Corrigendum - 5 dated 09/01/2026 to CPC Tender No. BHEL/CPC / YNR/EPC-CHP/ 26 /047

Corrigendum - 5 to Tender for the work of “EPC PACKAGE FOR COAL HANDLING PLANT and BIOMASS HANDLING PLANT along with RAILWAY SIDING WORKS AT 1X800 MW, SUPER CRITICAL EXPANSION UNIT, DCRTTP, YAMUNA NAGAR, HARYANA”

1. Annexure-23: Space Requirements for SW PW Pipes on CHP Trestle

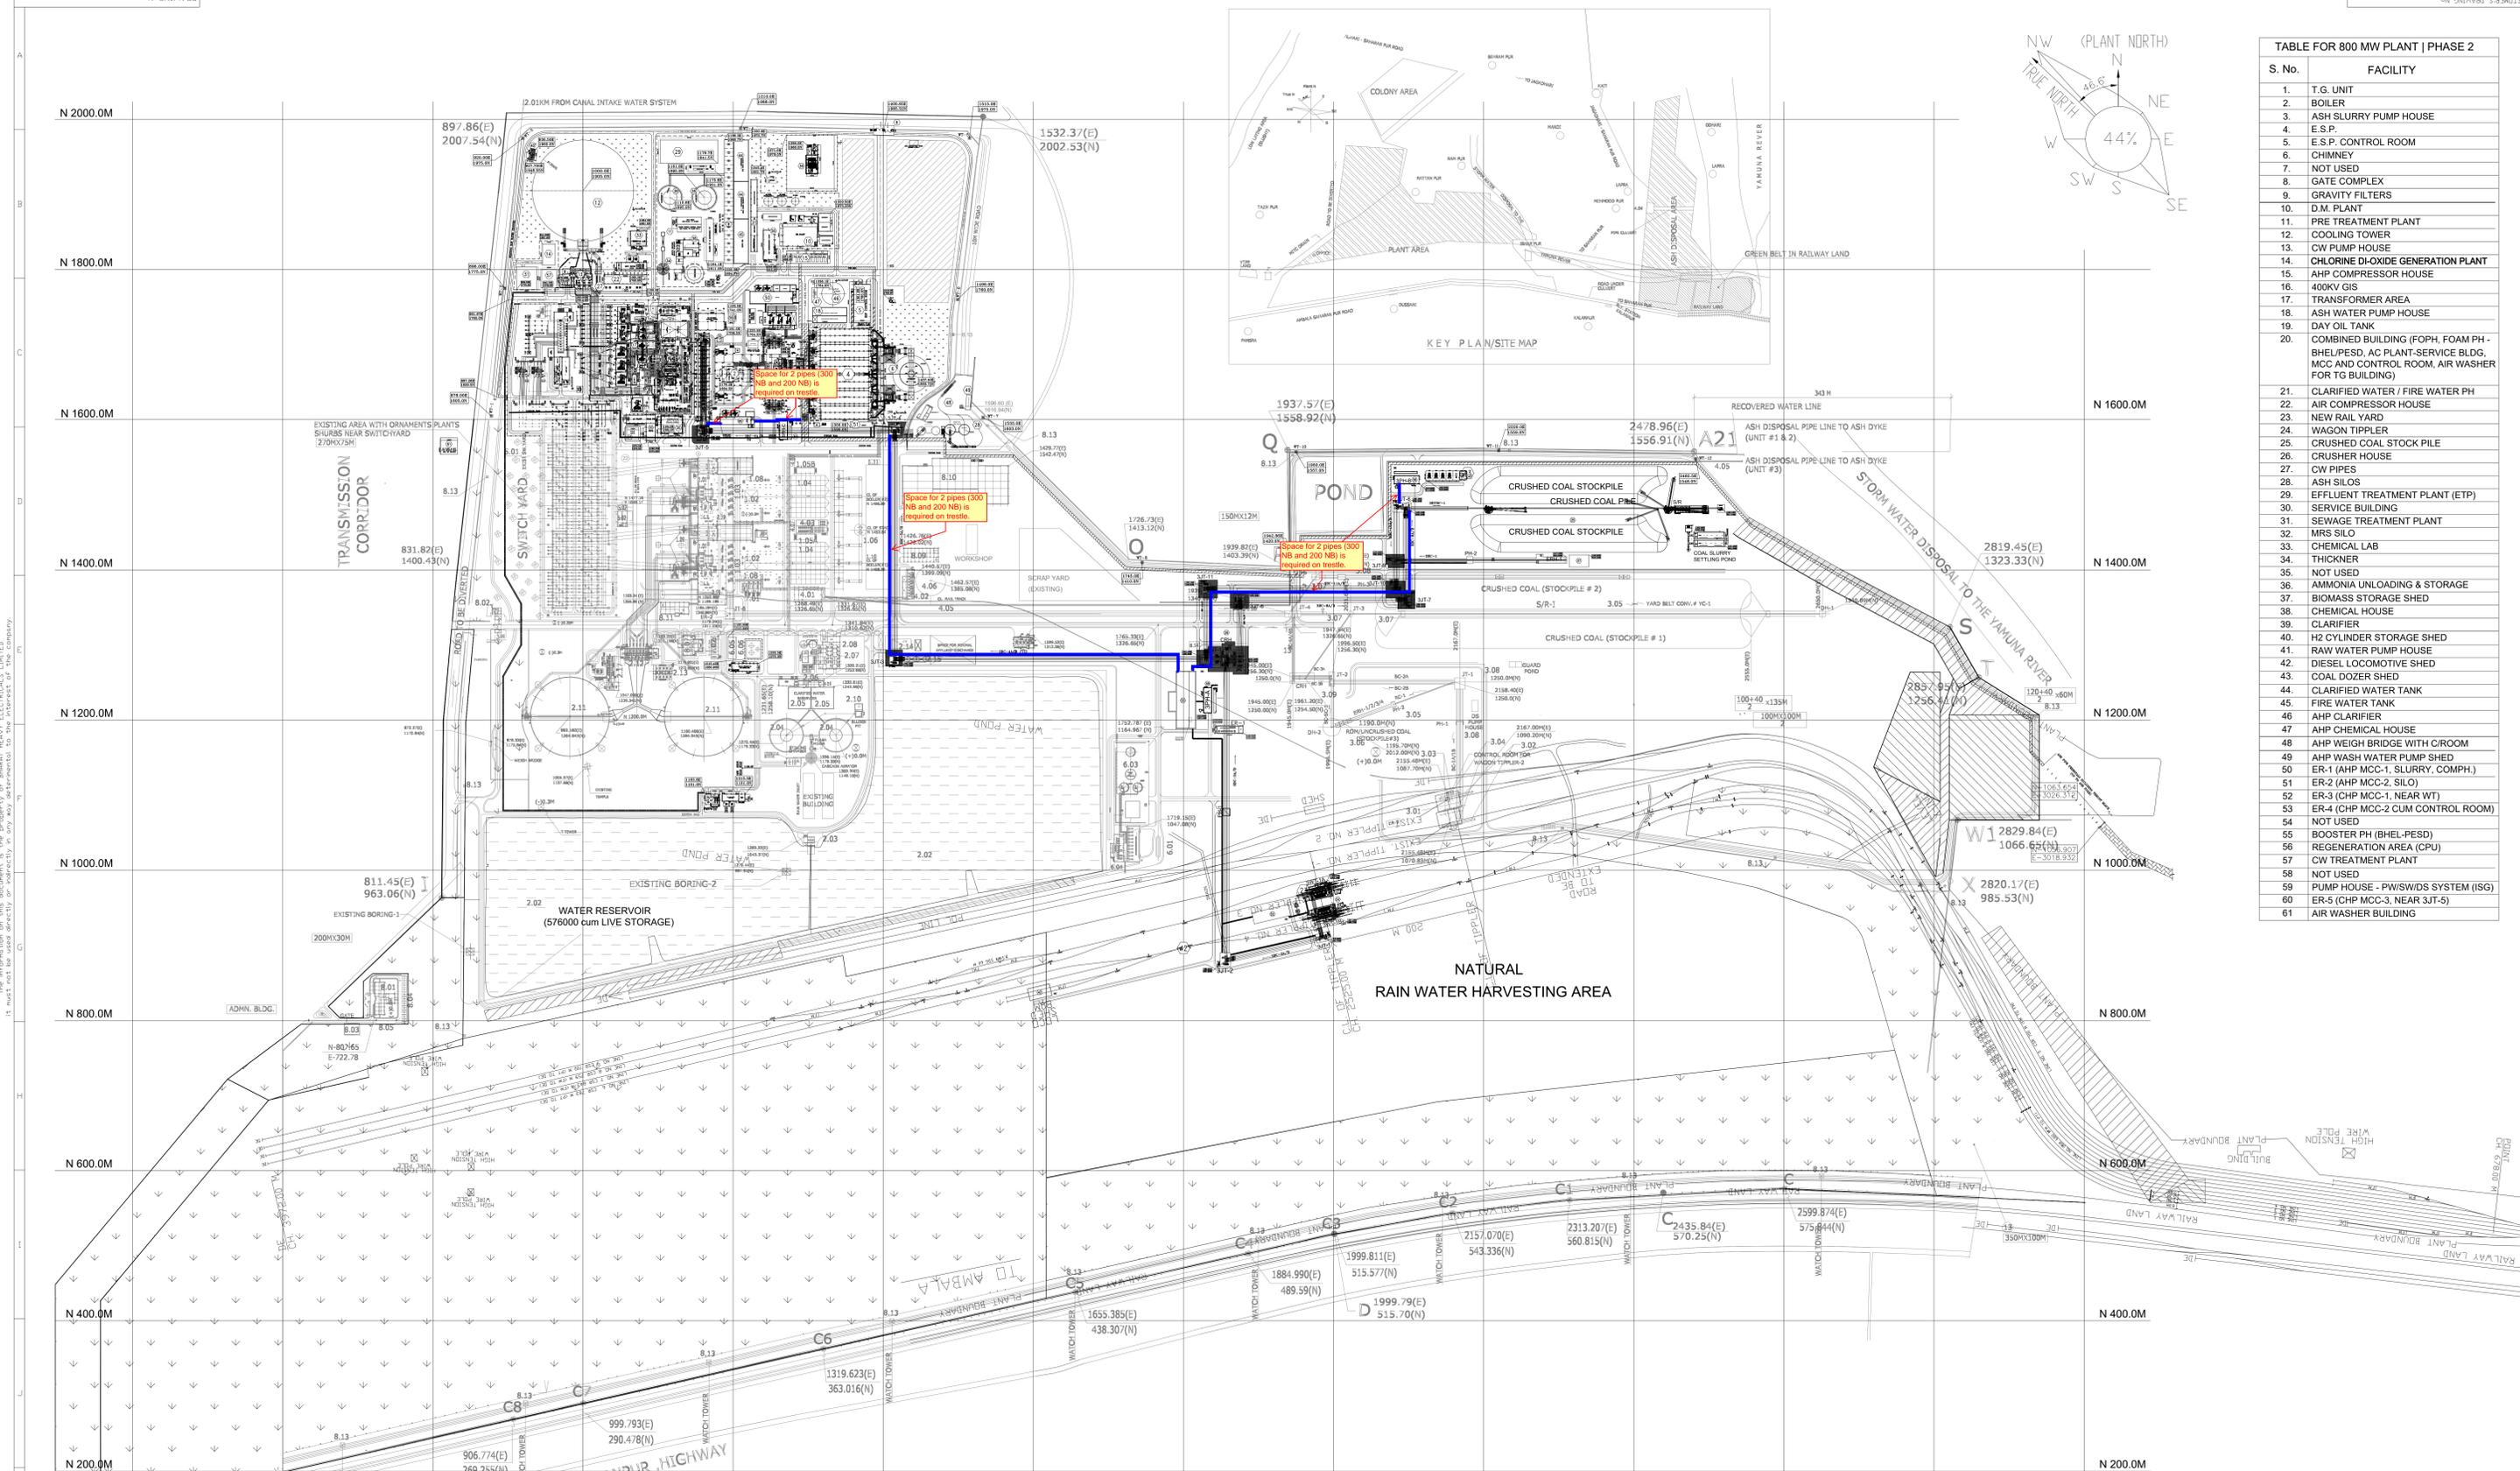
Sl. No.	Reference clause of Tender	Existing Clause	Revised Clause
1.	TCC-Chapter-XVI Clause 16.1	Additional Annexure	Annexure-23 Space Required for SW PW pipes on CHP Trestle Bidder to consider the space requirements for the SW and PW pipes on th trestle shown in the attached annexure however, CHP MCC building location & qty, cable trestle and the routing shown is tentative and may change based on Bidders Engineering.
